IEEE 802.3cg Unbalanced PLCA Issue September 2018

Unbalanced PLCA Issue

What we see instead, is:

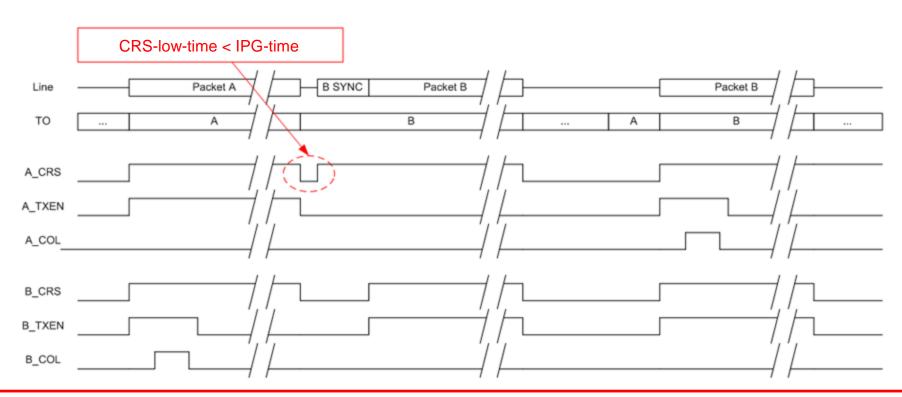
- Sometimes, the pattern is ABB instead AB
- Results in a 1:2 bandwidth ratio instead 1:1
- unbalanced bandwidth distribution w/ PLCA

→ An unevenly balanced bandwidth distribution like this would circumvent the usability of PLCA for many fields, even if collisions will still be avoided!

Proposal

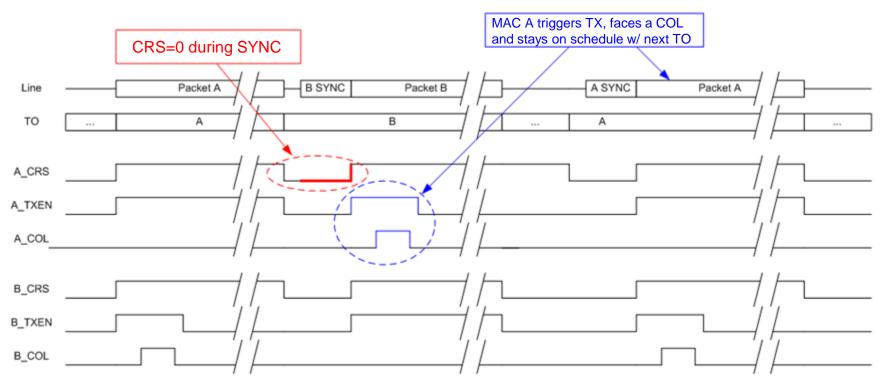
- Always de-assert CRS between two adjacent packets for at least the min. IPG time
- We can achieve this by keeping CRS de-asserted also during the PLCA SYNC period

- In Figure 148-6 (IEEE Draft P802.3cg/D2.0)
 - Change "if plca_crs = TRUE"
 - to "if plca_crs = TRUE * rx_cmd != COMMIT"
 - Also see comment #613

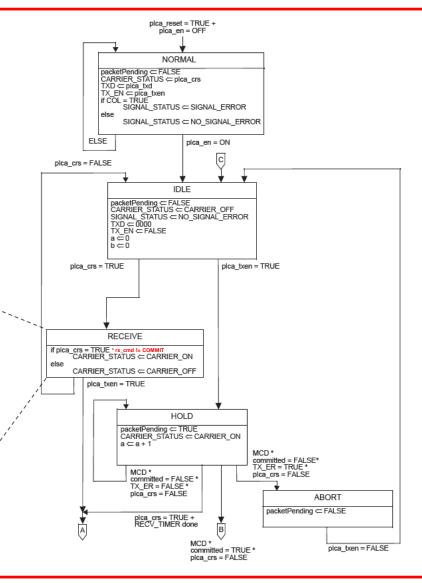
- According to the current spec, PLCA RS will de-assert CRS only for a short time, smaller than the required minimal IPG time
- MAC of node A will not be capable to start transmission of its next pending packet during this period, and may lose its next TO
